JOB NO	99-243-02
SHEET	1
OF	1

S/L 2 TURNBURY SUBDIVISION
VOL. 20 - PG. 33 LAKE COUNTY PLATS
PERRY TOWNSHIP LAKE COUNTY OHIO

SITE PLAN
FOR
RICK DOWNING

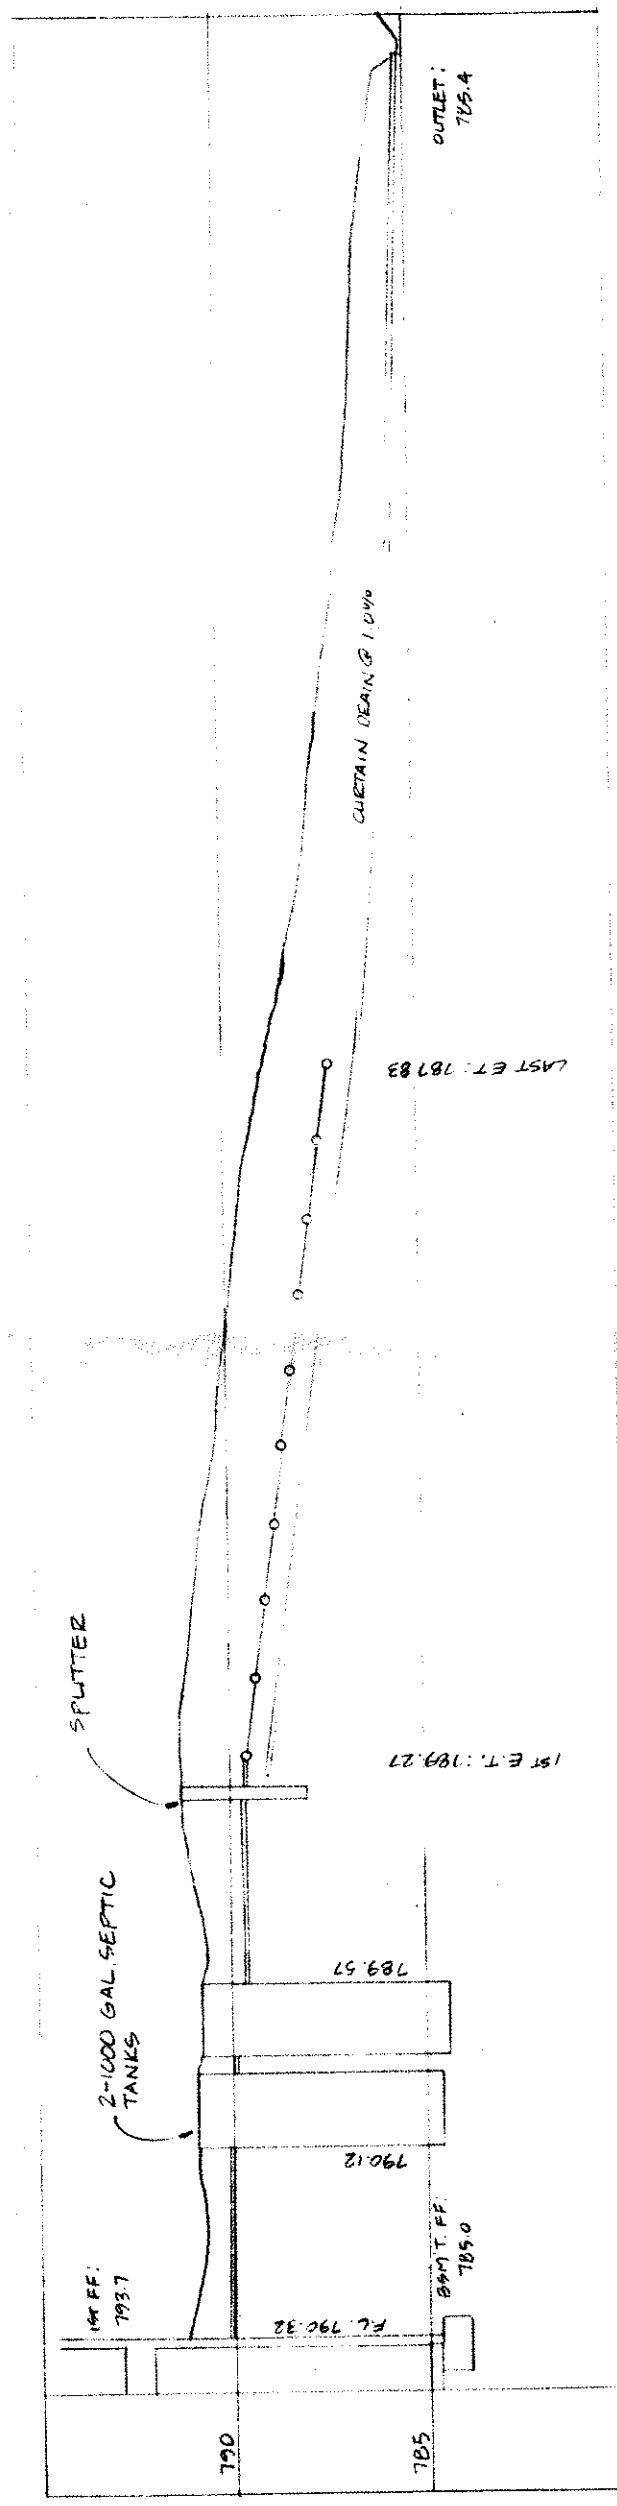
Reviewed and Accepted _____
LAKE COUNTY GENERAL HEALTH DISTRICT
Date 3-24-95 May need a life
JOEL LUCIA, R. S., M. P. H.
Health Commissioner
BY J. Lucia

System is in accordance with overall on-site sewage disposal system plan.

Reviewed by: Chun-Li Date: 3/22/95
BY Consultants, Inc.
